DRB Application No.: 03-00302 (SBP)	Project # 1002507
Project Name: ALAMEDA BUS. PK LOT 43	EPC Application No.:
Agent: Sanders & Associates Architects	Phone No.: 842-8413

DEVELOPMENT REVIEW BOARD TRANSPORTATION DEVELOPMENT Standard Comment Sheet

**CITY OF ALBUQUERQUE
PLANNING DEPARTMENT
Development Review Board
3/12/03 Comments**

Subject: Alameda Business Park, Lot 43/SBP

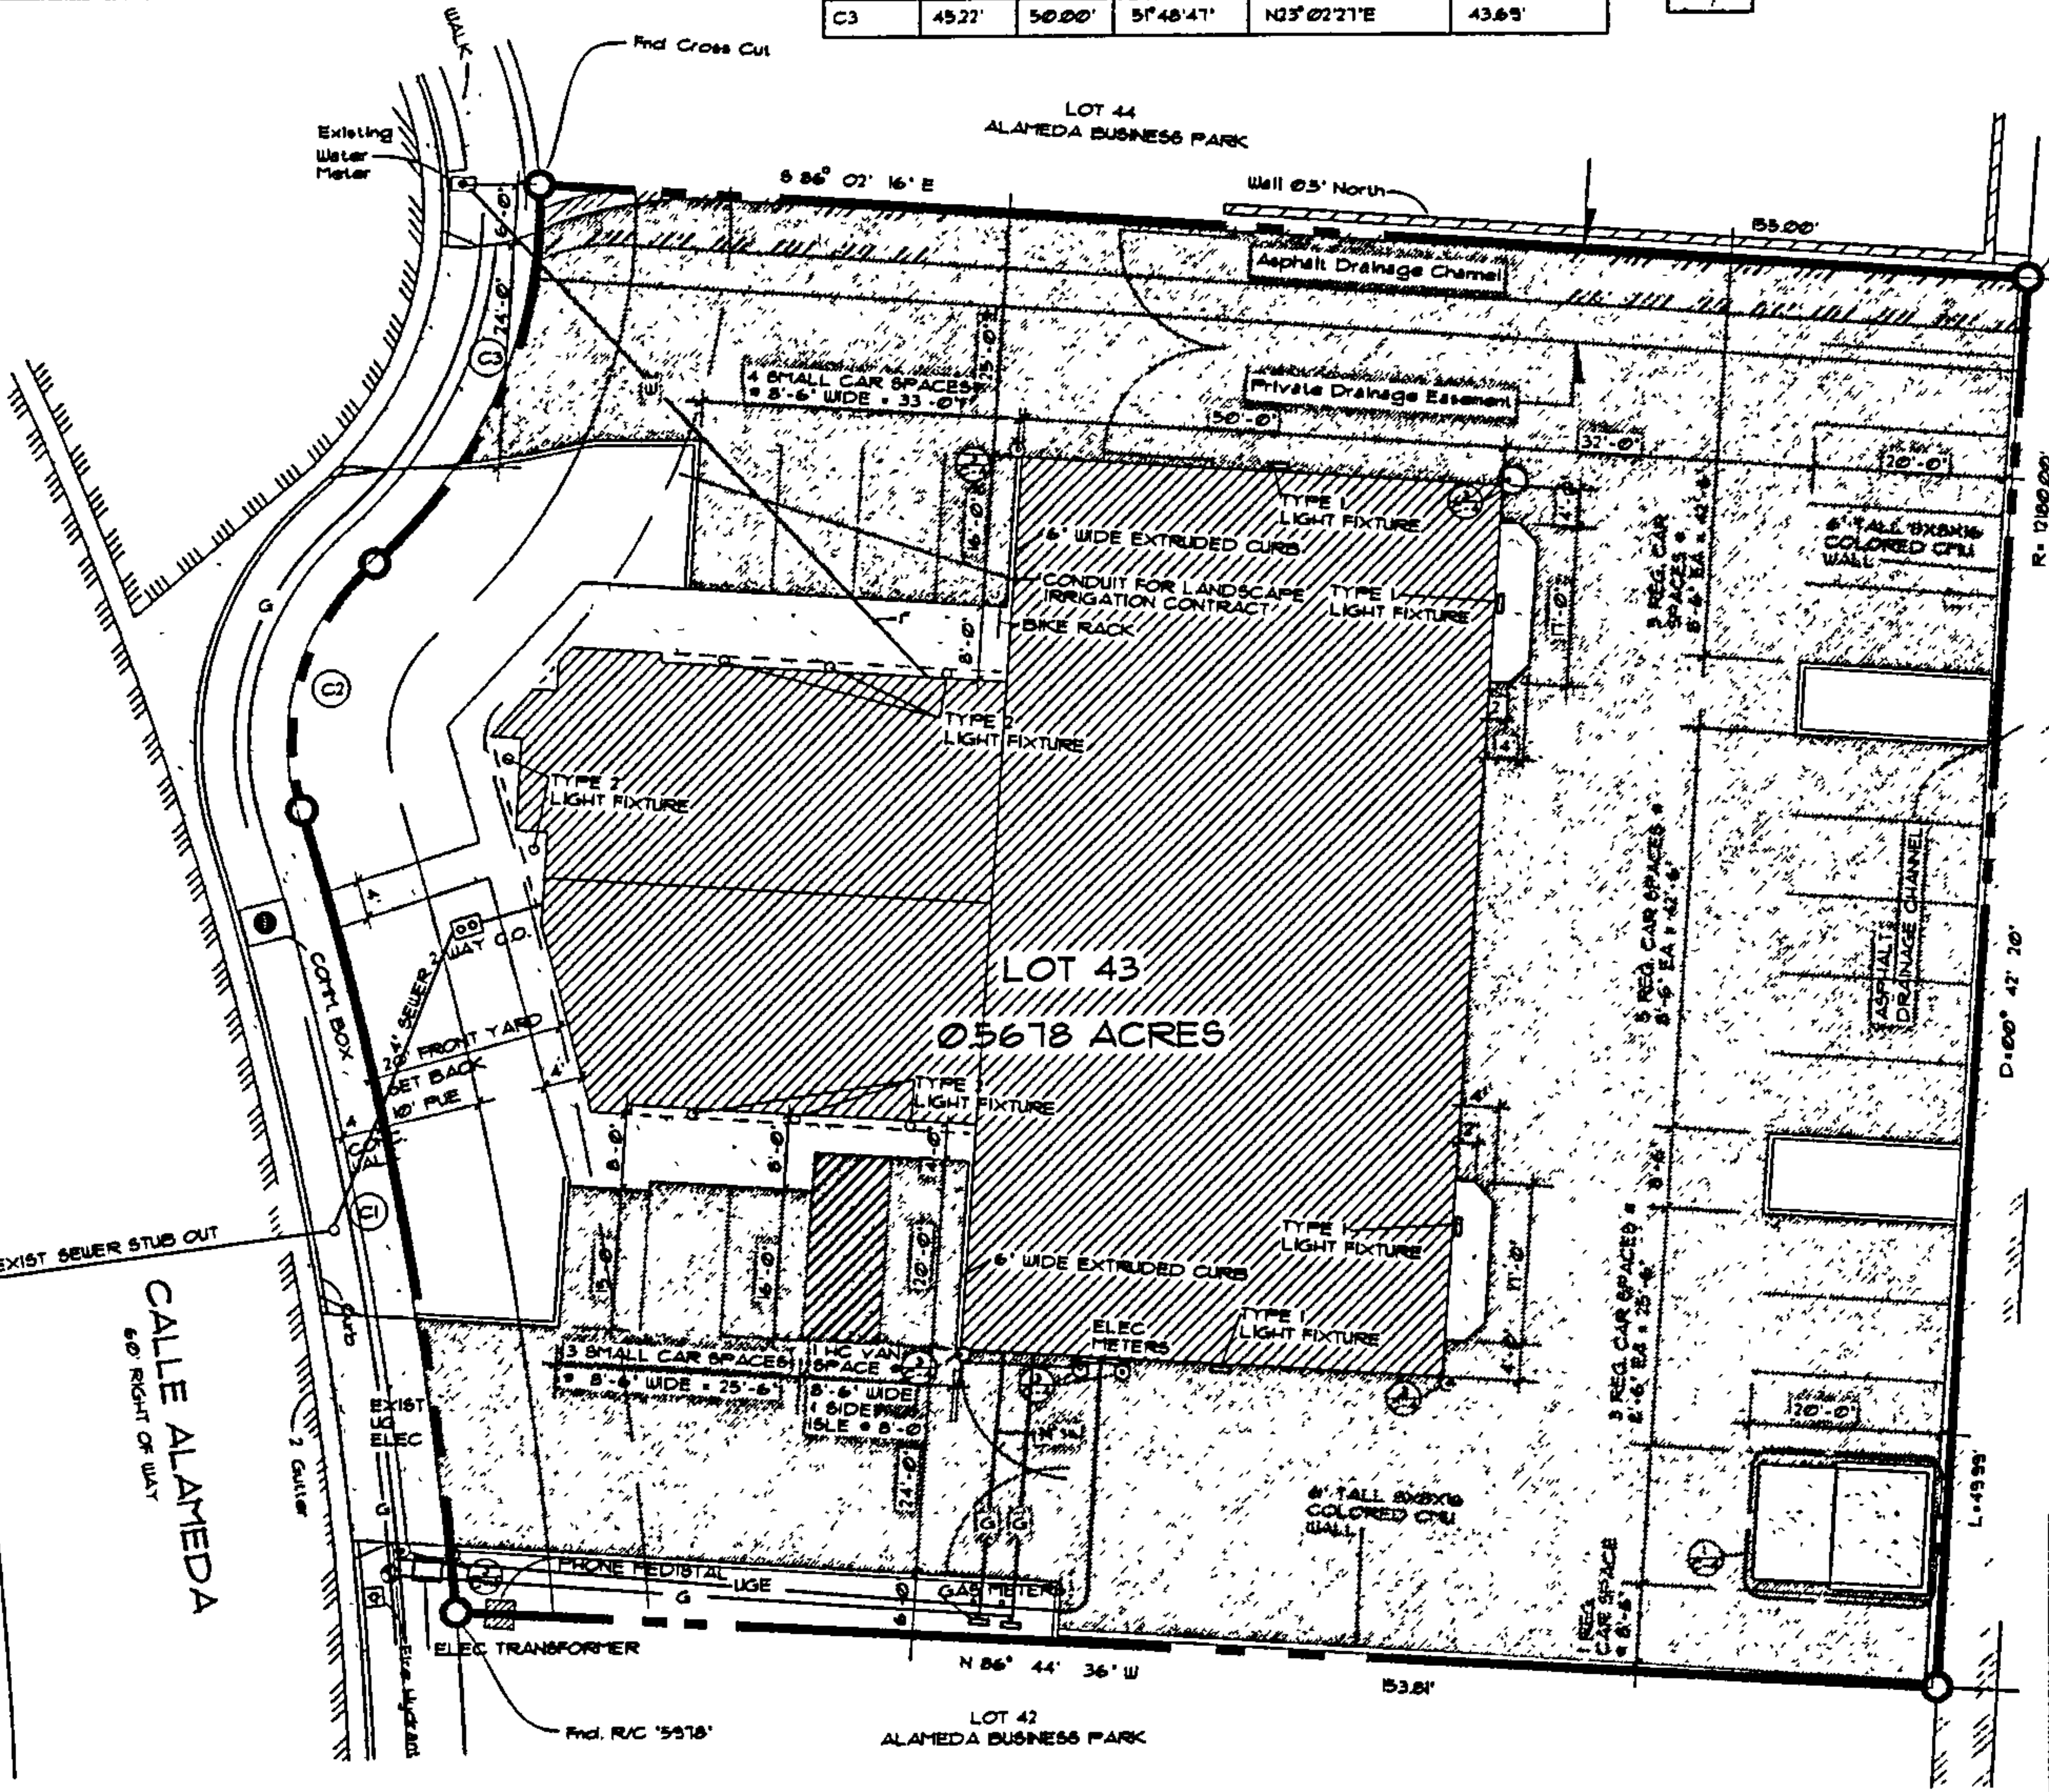
The dumpster is not marked on the site plan.

The south side of the property should have a 6' landscape buffer all the way to the east property line. There is enough parking spaces to lose the one to the south of what we assume is the dumpster.

Signs are not shown on the elevations page or the site plan. Signs should be shown and conform to the Master Plan requirements.

The dumpster is not marked on the site plan.

The south side of the property should have a 6' landscape buffer all the way to the east property line. There is enough parking spaces to lose the one to the south of what we assume is the dumpster.

Signs are not shown on the elevations page or the site plan. Signs should be shown and conform to the Master Plan requirements.

1 SITE LANDSCAPING PLAN
 SCALE: 1" = 10'-0"

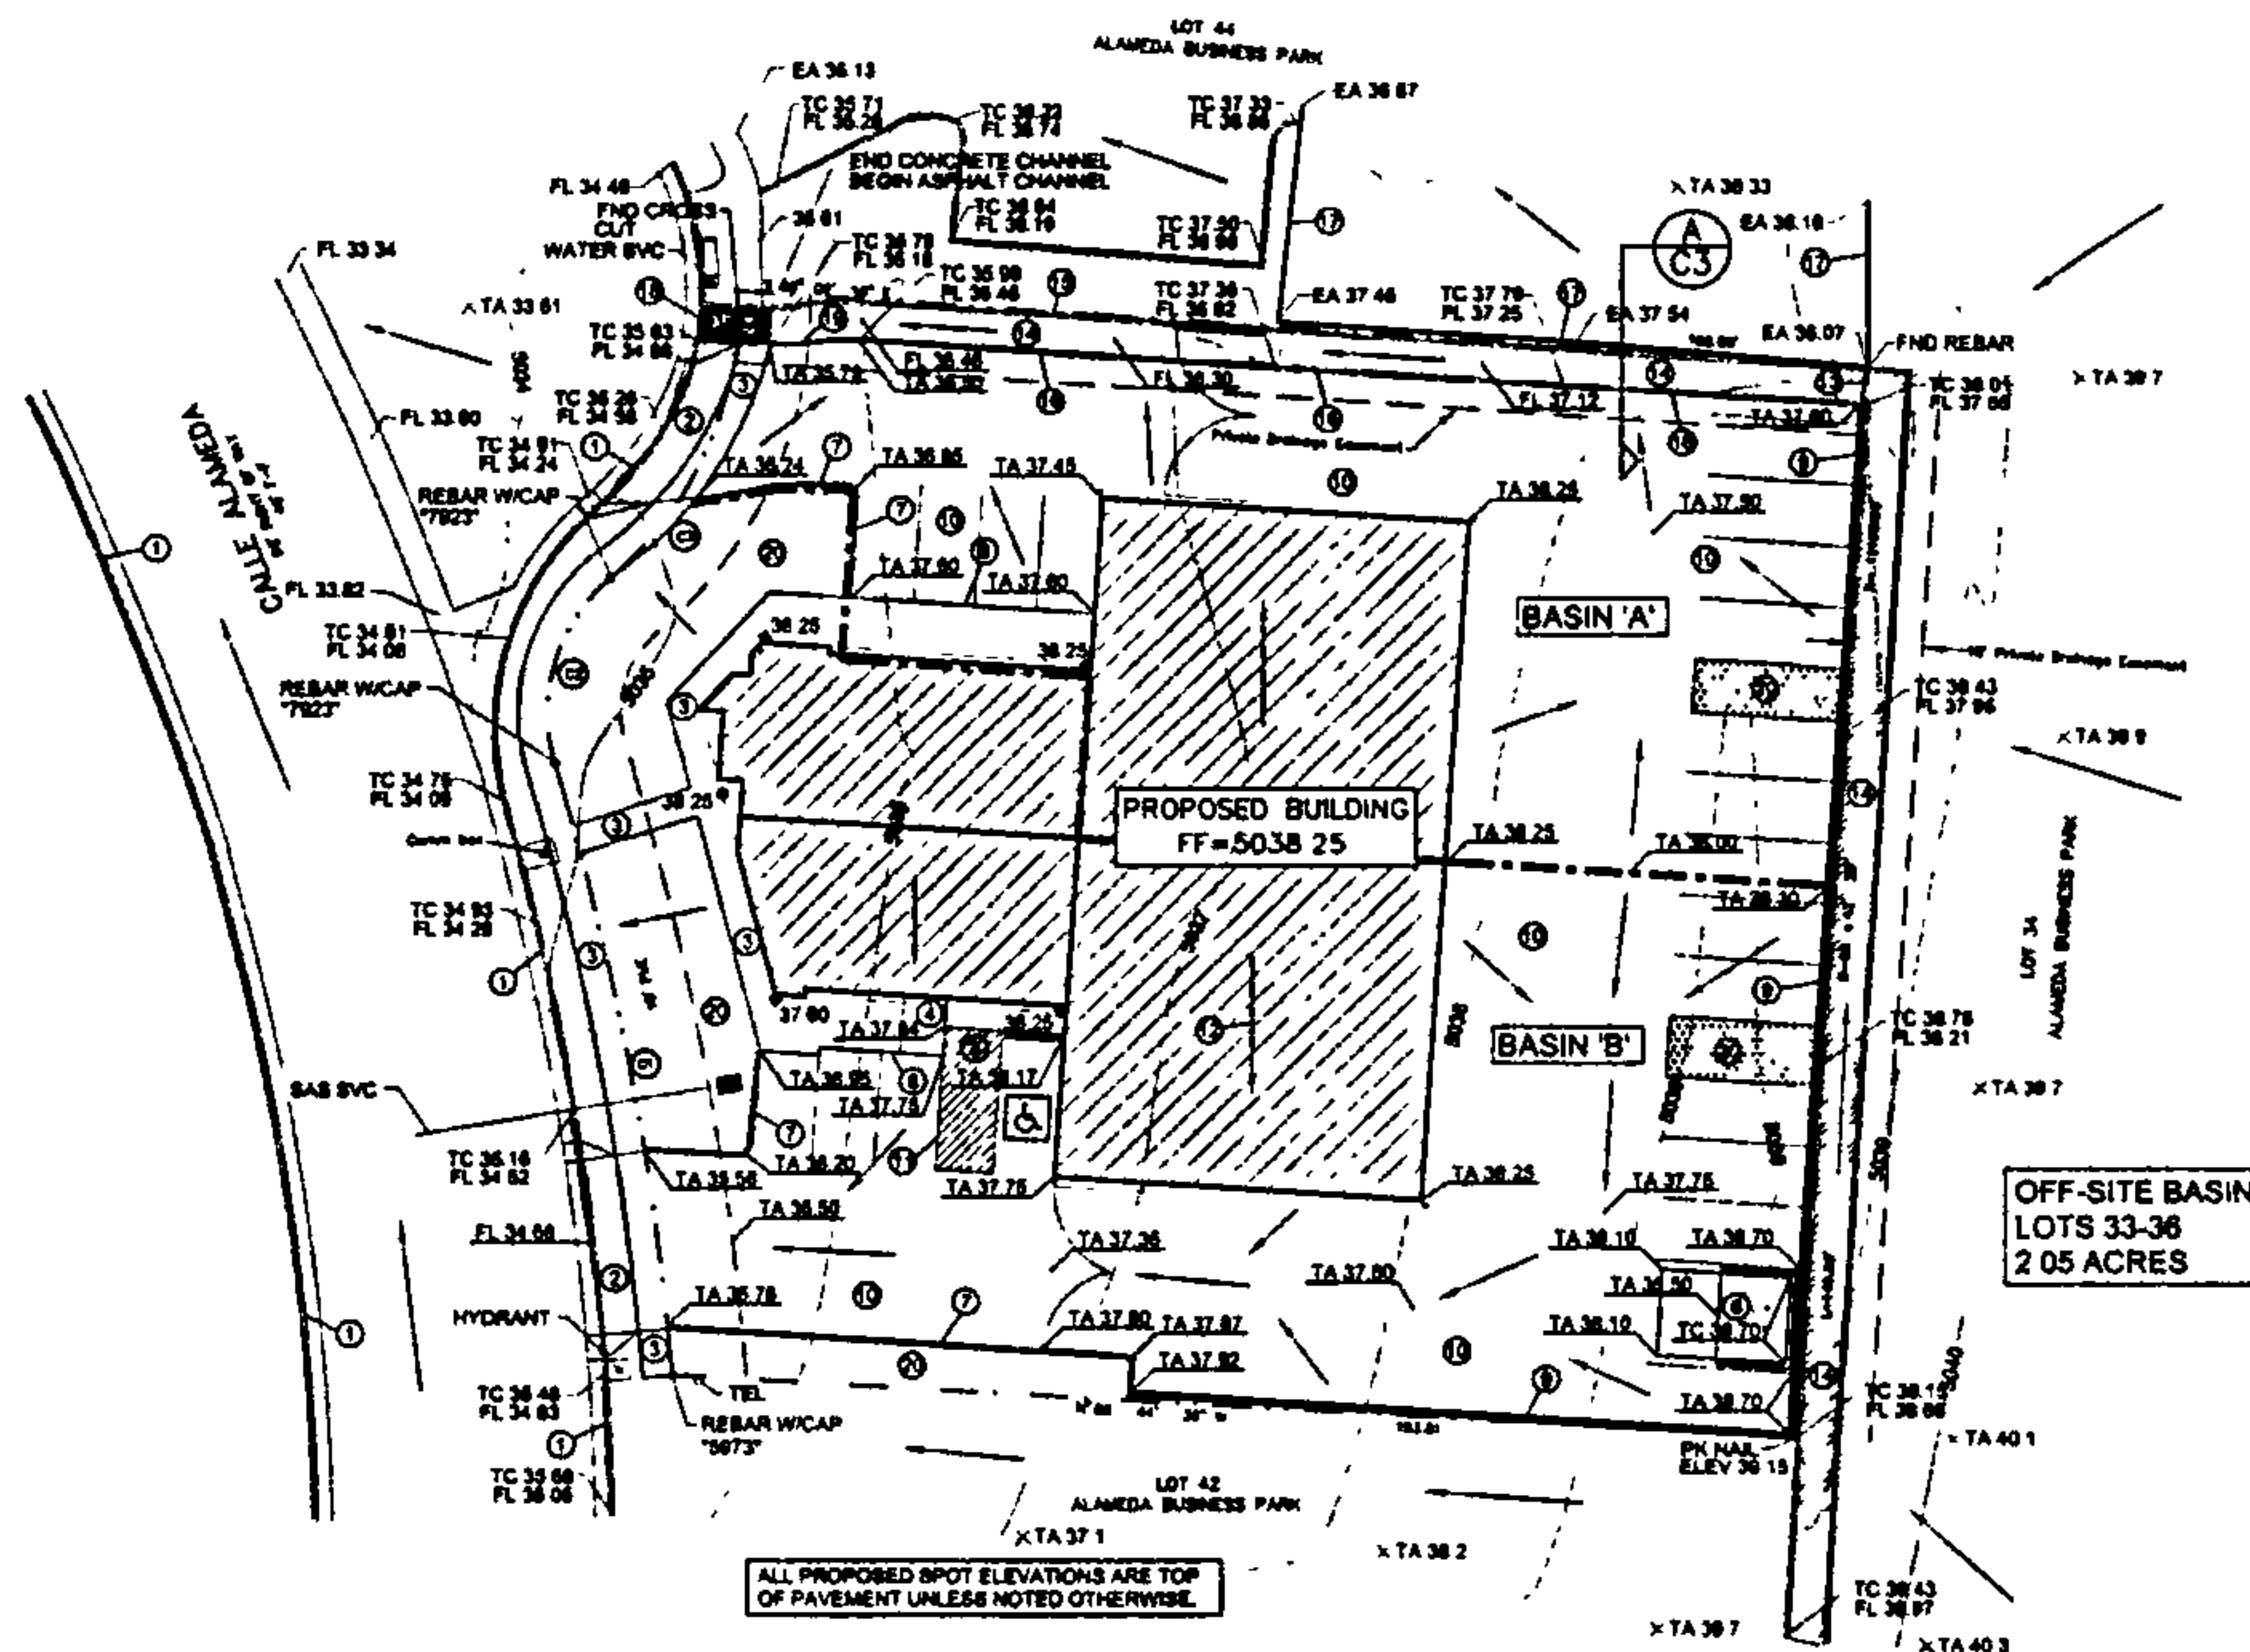
Not all of the plants & trees listed on the landscape plan conform to the plants & trees listed on the Master Plan as required by that plan.

Not all of the plants & trees listed on the landscape plan conform to the plants & trees listed on the Master Plan as required by that plan. .
